The Core Watershed Question

Bias in the Service of Expediency?

EXHIBIT 5

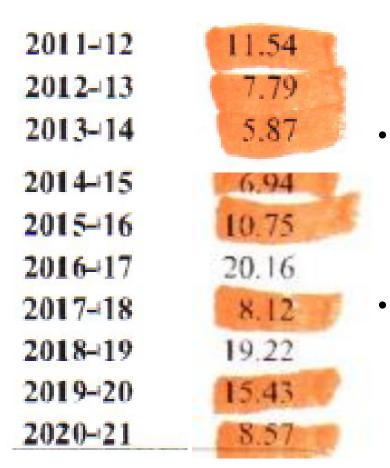
ACCORDING TO THE SB COUNTY FLOOD CONTROL DISTRICT (Buellton station) we have had below average rainfall in <u>8 of the last 10 years</u>- between

2011/12 and 2020/21

- The temptation is always to pump more during a drought, not less. Dryland farmers plan worst case water scenarios based on acreage and plant types.
- 20+ acres of cannabis and 26 acre-feet of water might be too much for our tiny watershed in an extended drought. The fact is, we don't know, but we can know much more. We have unused relevant data.
- If the cannabis grower's business revenue forecast is based on 20+ acres and 26 acre-feet of water, the business reality is that Nojoqui Farms will pump 26 acre-feet from all available sources (metered AND unmetered wells) to meet their revenue objectives.
